Pless Environmental, Inc.

February 29, 2016

*Re: Review of Phillips 66 Company Rail Spur Extension and Crude Unloading Project
Final Environmental Impact Report and Vertical Coastal Access Project Assessment*

Figure 2: Mainline Locomotive Cancer Risk, by speed and distance from Mainline
From: Final EIR, Figure 4.3-9

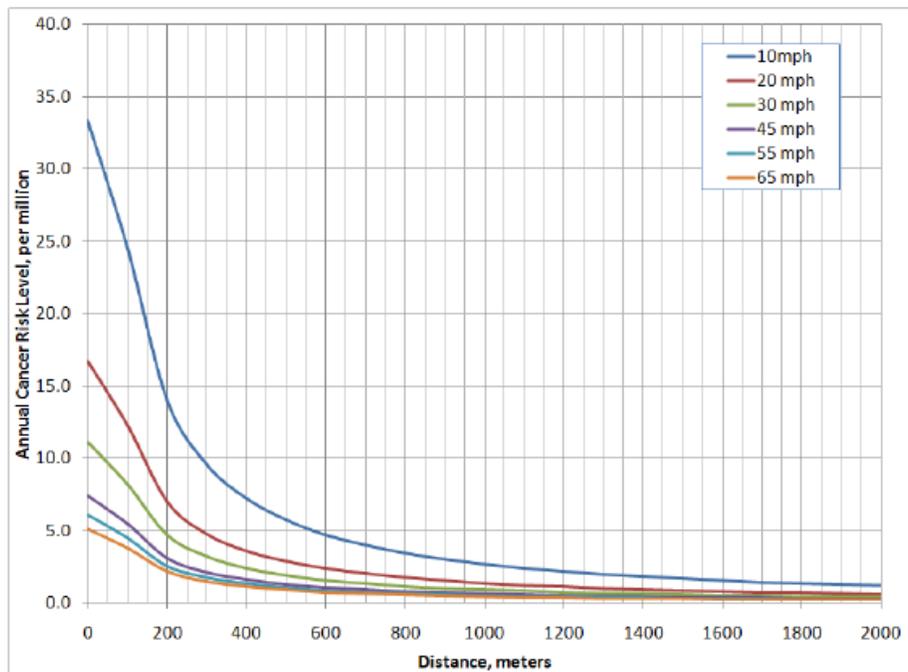
the Final EIR also substantially underestimates health risks (*see* Comment II). In fact, the Final EIR in the section discussing cancer risks for the uprail air districts recognizes and illustrates the inverse relationship between train speed and emissions of carcinogenic diesel particulate matter emissions, as shown in the excerpt in Figure 2.

As shown, the higher the speed, the lower the emissions and resulting cancer risk or, the lower the speed, the higher the emissions and resulting cancer risk.

These estimates for cancer risks near the Refinery are based on substantially underestimated emissions because they rely on an average train speed of 40 mph, as discussed in Comment I. As shown in Figure 2 above (excerpted from the Final EIR), emissions and cancer risks increase at lower speeds as the locomotives spend more time traversing a certain distance. The Final EIR did not take into account that trains slow down near the Refinery but instead assumed a constant speed of 40 mph all the way to the unloading rack. Thus, the Final EIR fails to identify the magnitude of health risks near the Refinery and fails to require adequate mitigation.
